NEW BRITAIN TOWNSHIP

CONDITIONAL USE HEARING APPLICATION

RE: 396 King Road – Revised Plan Submission
TMP#: 26-004-030
New Britain Township, Bucks County, PA
HCE Project No.: 1734

We are in receipt of a review letters for the above-referenced project. Enclosed are copies of the revised documents. Below please find responses to each of the comments contained in those letters.

File No.	1734_C0.2 ERSAP.DWG
HCE Job	1734
Date	09/14/2022
Scale	1"=80'
Designed	EC
Sheet	4 of 15
Drawing No.	C0.3

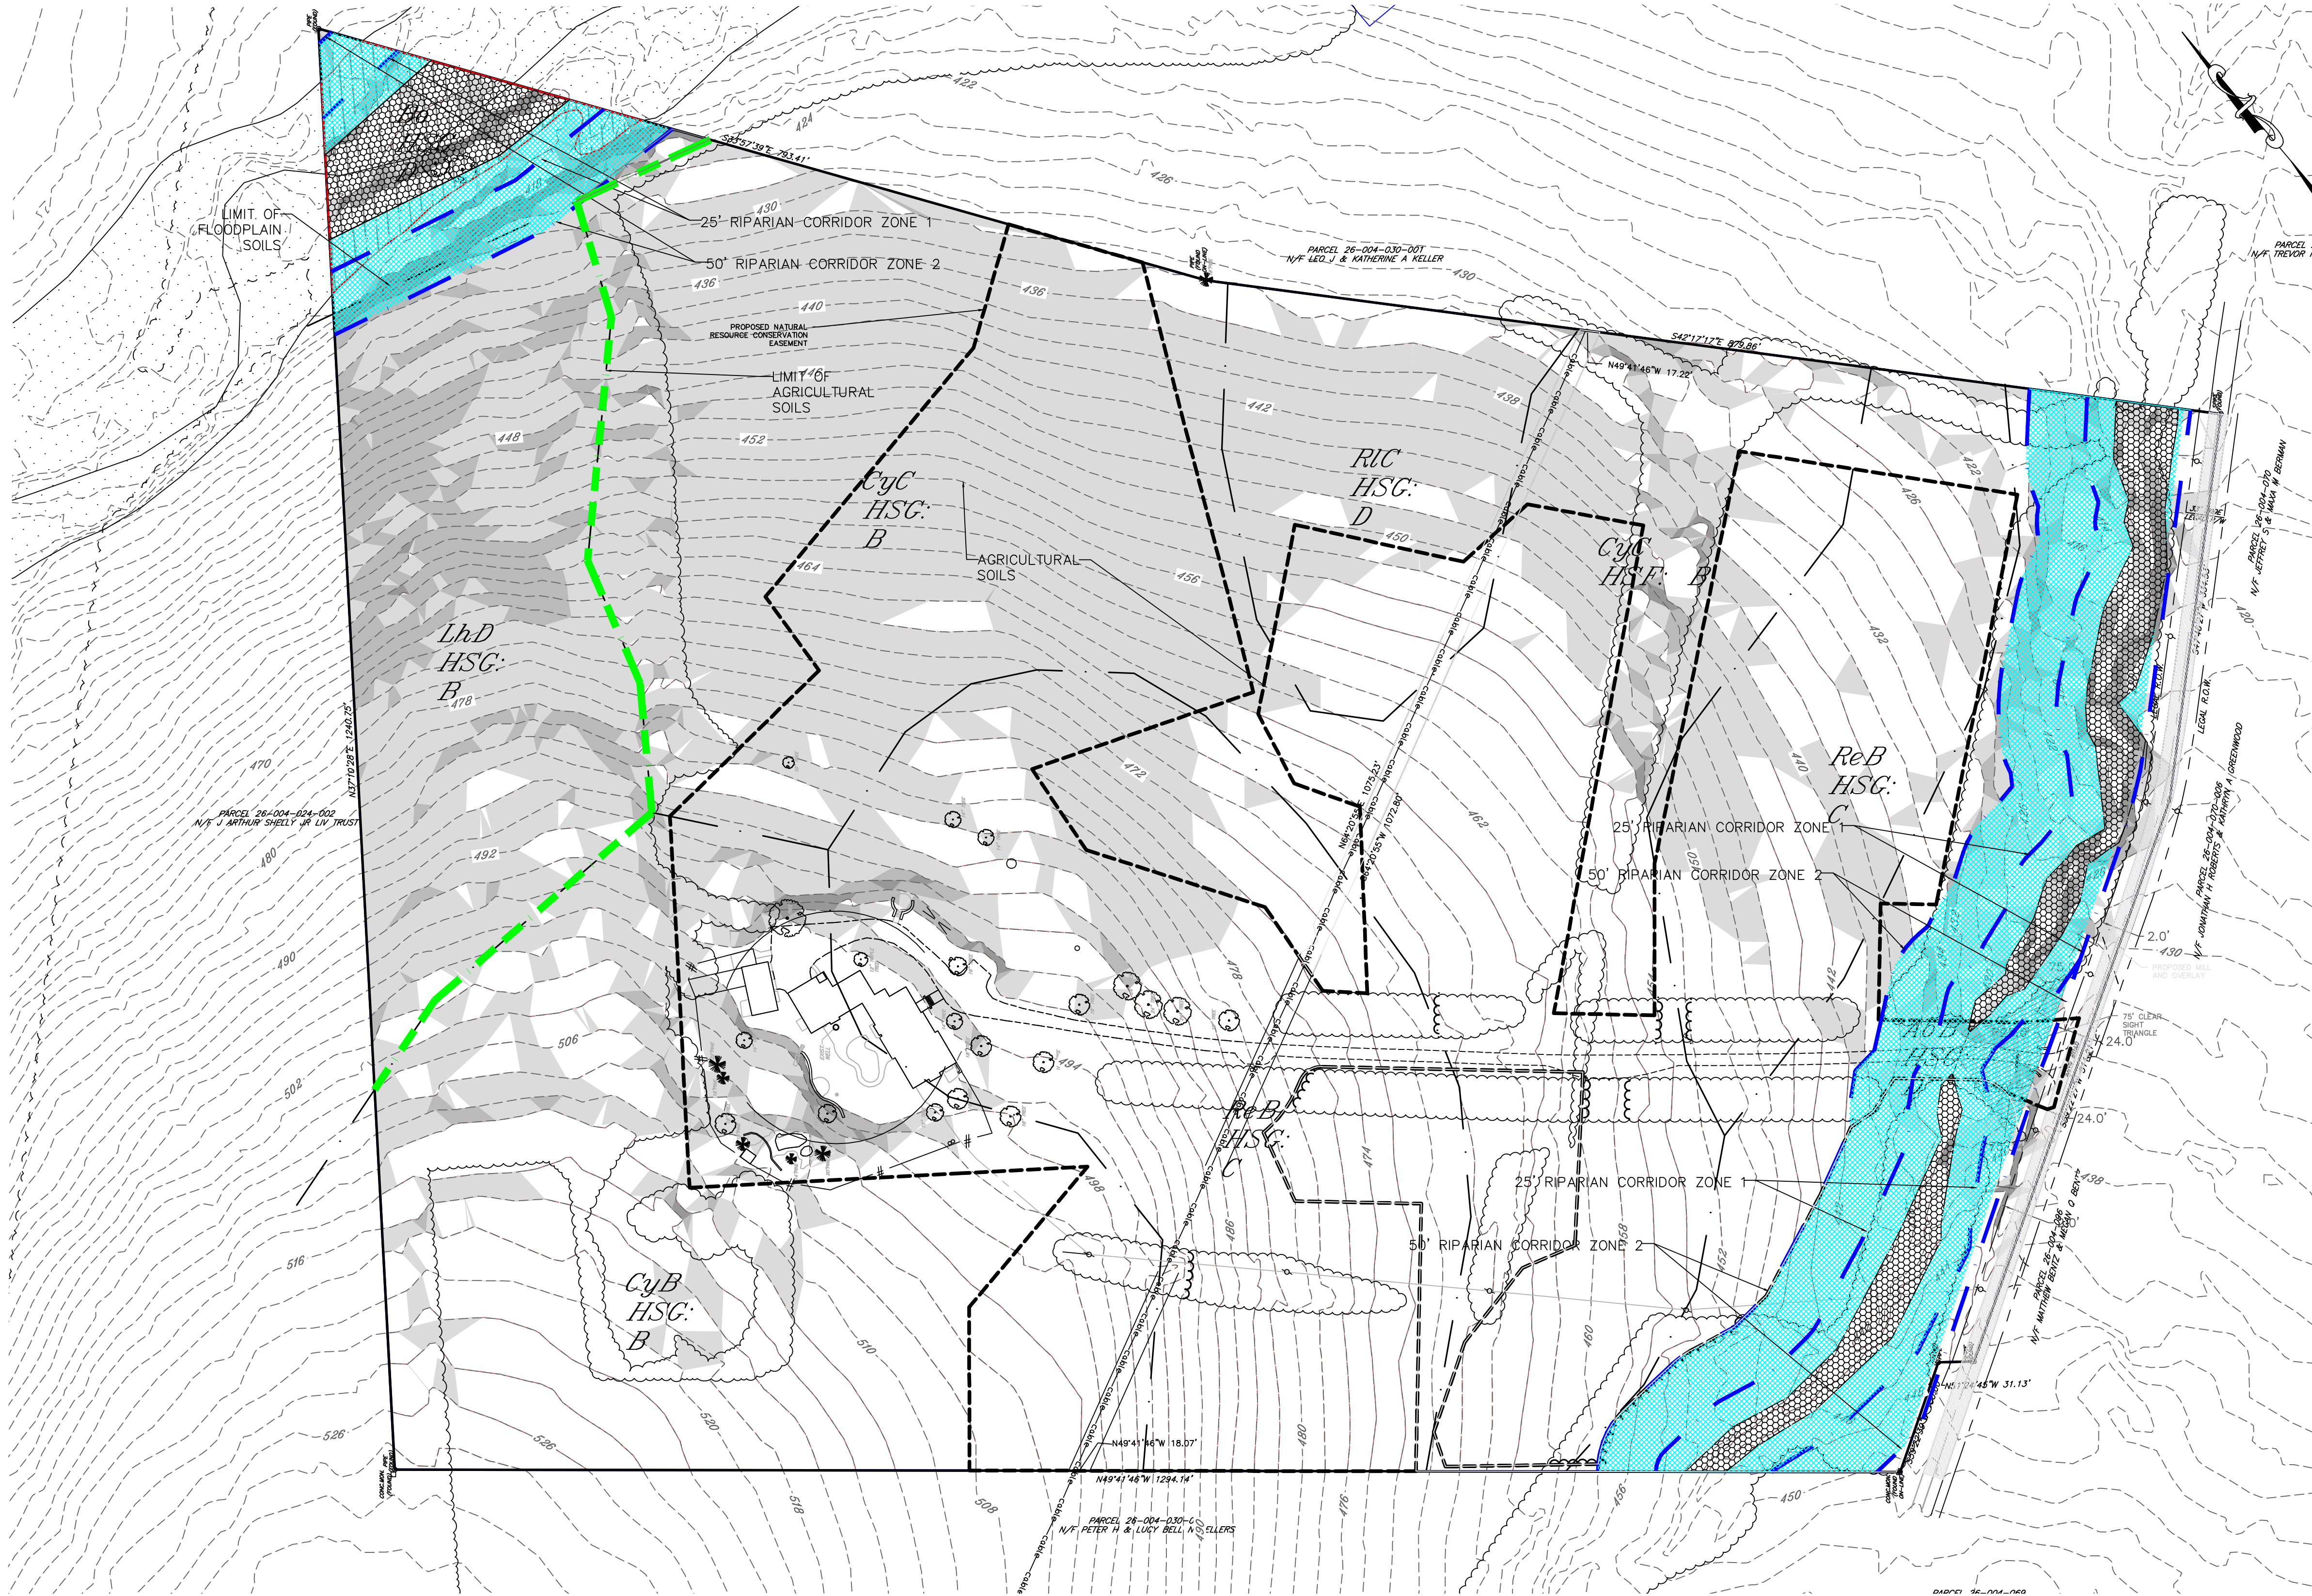
4. §27-505.2. – The Resource Protection Standards table on Sheet 4 notes 32.154 acres of agricultural soil onsite. The area of agricultural soil shall be delineated on the Existing Resource and Site Analysis Plan to demonstrate the 50% protection ratio is achieved.

7. §27-2400.c – The Resource Protection Standards table on the Existing Resource and Site Analysis Plan notes 0.536 acres of floodplain soils. The boundary for the floodplain soils (Bo soils) does not appear to be consistent with the web soil survey map and the Bucks County Parcel and Floodplain Map which both show an area close to 1 acre at the northern corner of the site. The floodplain soils area shall be verified and revised as necessary.

9. §27-2401 – The Site Capacity Calculations shall be coordinated with the Resource Protection Standards on the Existing Resource and Site Analysis Plan. These areas shall be reviewed and revised for consistency and discrepancies related to overlapping resources clearly noted.

Response: The area of agricultural soils has been added to the Existing Resource and Site analysis Plan.

Response: The floodplain soils line has been verified and revised.

Response: The Site Capacity Calculations and Resource Protection Standards have been revised accordingly.

File No.	1734-C-010 RECORD.DWG
HCE Job	1734
Date	09/14/2022
Scale	1"=60'
Designed	RC
Sheet	5 of 15
Drawing No.	C1.0

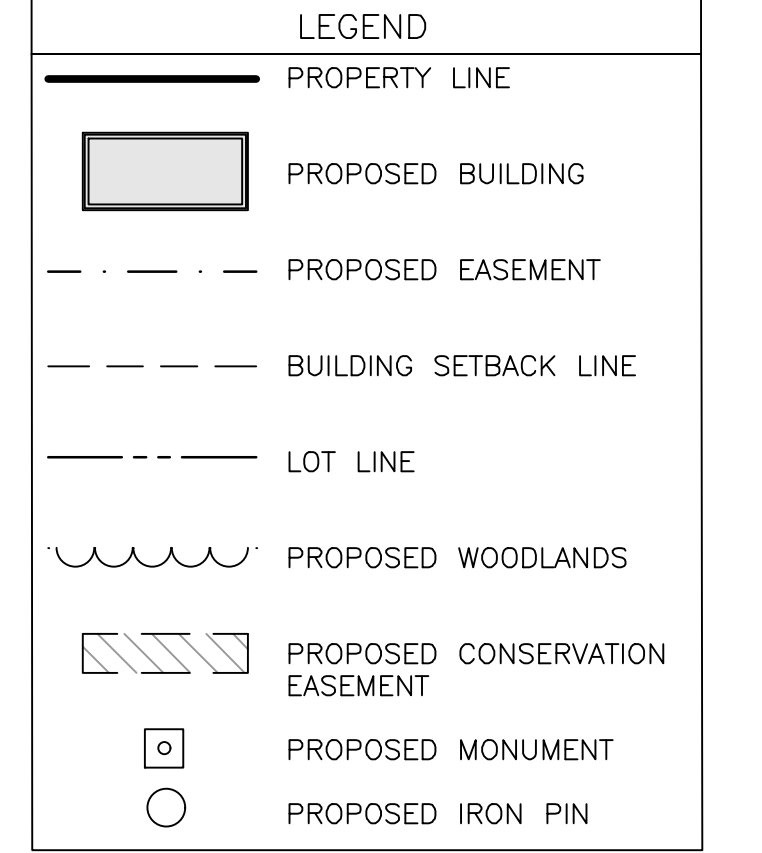
future subdivisions. If the lots are to be deed-restricted, a note to this effect shall be added to the Record Site Plan, Sheet 5 of 14, and included in a Deed of Restrictions.

11. §22-704.1 – Note 4 on Sheet 5 of 14 indicates that Henry Court will be privately owned and maintained. We recommend that the street be recorded as a Private Access Easement and not as an Ultimate Right-of-Way. The wording shall be revised accordingly, and the legal description noted as such.

- a. Per the Site Plan Note 5 on Record Site Plan, Sheet 5, the stormwater management facilities are noted to be a perpetual part of the stormwater management system of the Township. This shall be revised to state "of the homeowners or Homeowners Association" and to include the road culverts.

- b. Per the Site Plan Note 5 on Record Site Plan, Sheet 5, access is provided to the properties for stormwater inspections by the Township and its agents. It shall be clarified whether a blanket easement or defined easements are proposed. Defined easements shall be a minimum of 20 feet in width.

Response: A note has been added to the record plan.

Response: Note 4 has been revised accordingly.

File No.	1734_C2.0 GRADING.DWG
HCE Job	1734
Date	09/14/2022
Scale	1"=60'
Designed	RC
Sheet	6 of 15
Drawing No.	C2.0

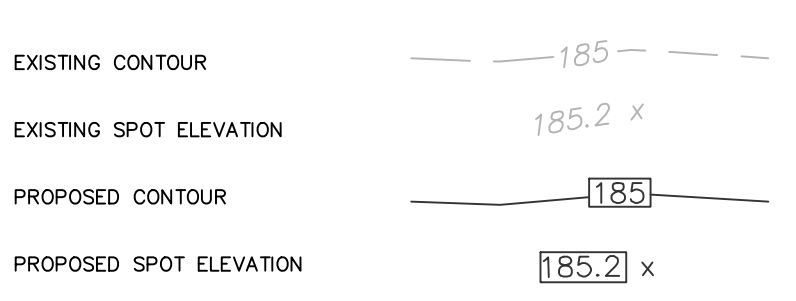
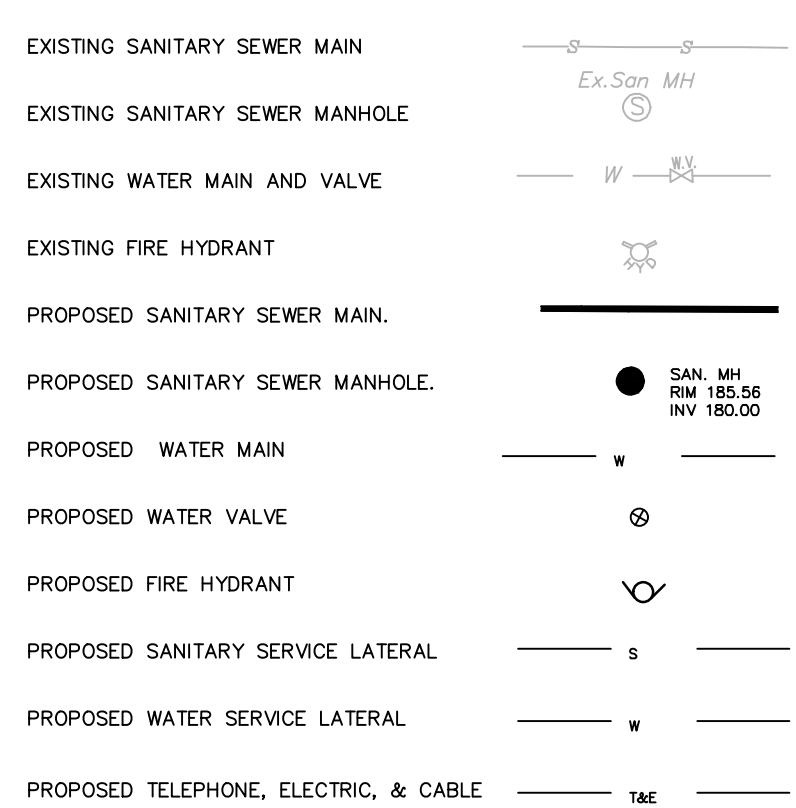
5. §27-2115 – No portion of an on-lot septic system shall be located in a manner that would block any stormwater drainage from any lot. A note to this effect shall be added to the grading plan.

Response: Note 13 has been added to the grading plan.

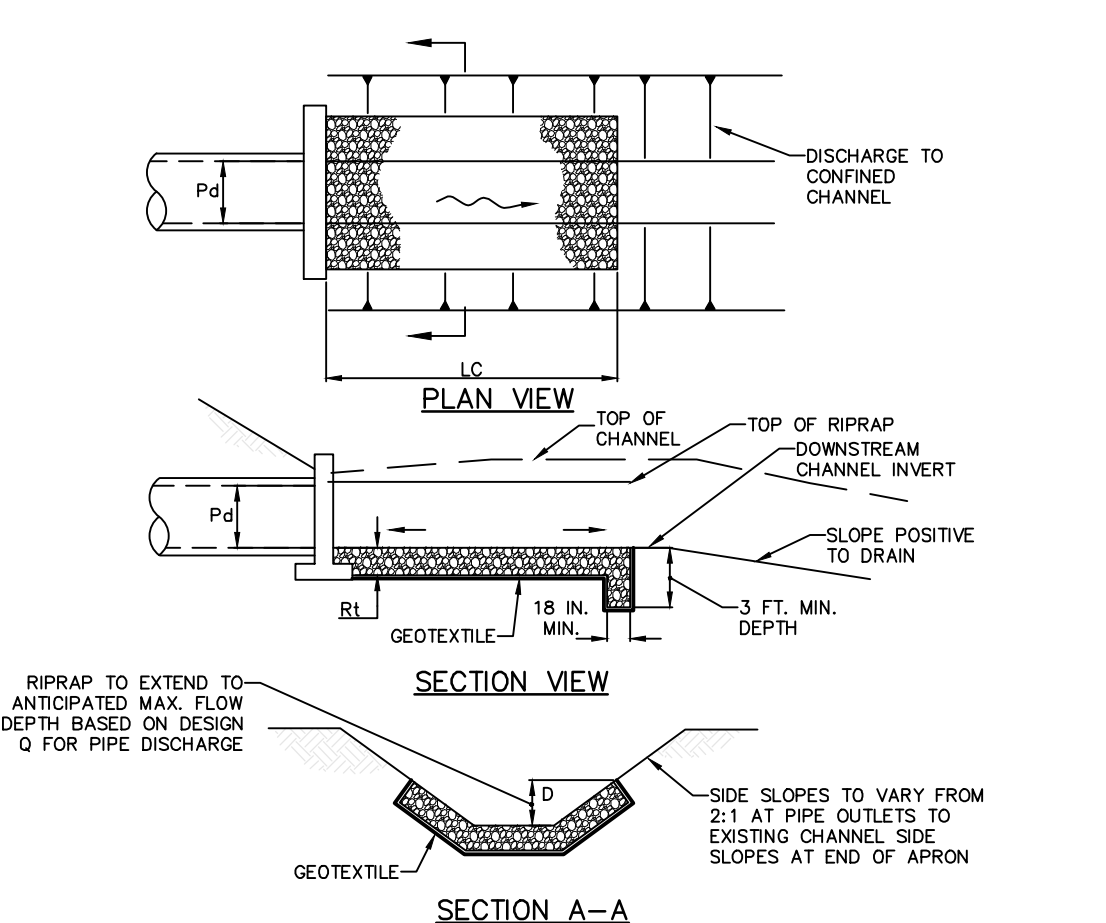
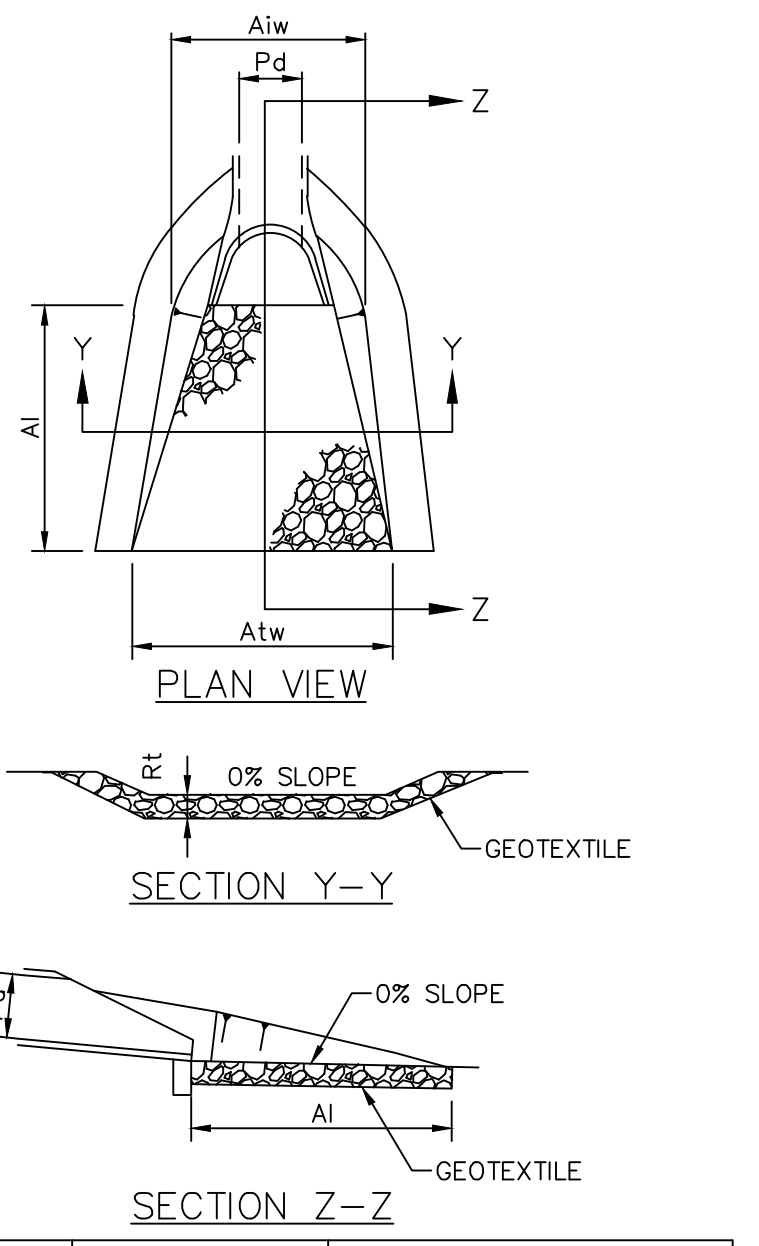
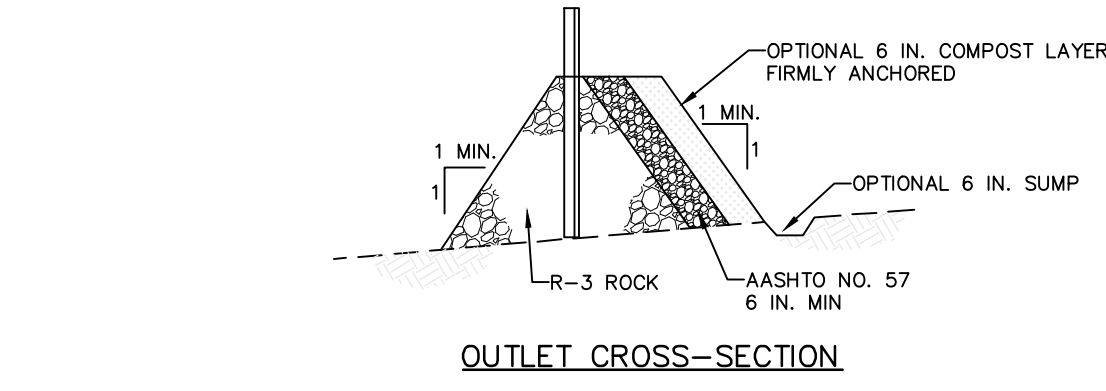
5. §22-712.8.D. – Rock apron shall be placed at all headwalls and endwalls. The rip rap apron details on Sheet 10 only reference PRA-1 and PRA-2 for Lots 1 and 2. The 24-inch pipe size listed in the detail for PRA-1 is not consistent with the proposed pipe. Rip Rap apron details shall be provided for the discharge pipes on Lots 1 and 5, for the 36" RCP culvert crossing Henry Court, and the 18" RCP along King Road.
